# Access Compliance Report

## Public Rights-of-Way

### (Curb Ramps)

Intersection ID: 9982	Main Street: E_36TH_ST	Cross Street: N_DAVIDSON_ST	Location: N
ADA ID: E4EEB7613F88	Ramp Type: PerpDiag	Initial Pass/Fail: Fail	Overall Compliance: No
Severity Score: 26.25			
Codes/Mitigation Info/Possible Solution		Field Measurements/Component Compliance

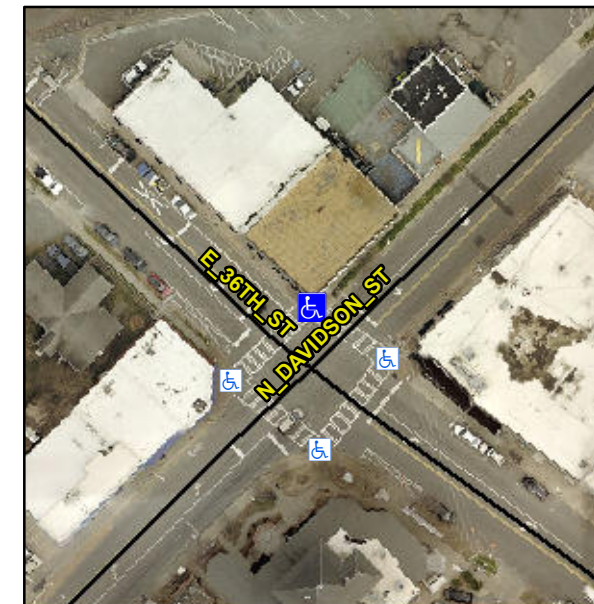
**Remove & Replace Curb Ramp With Two New Directional Ramps or Equivalent.**

**R304.2.2, R304.5.3**
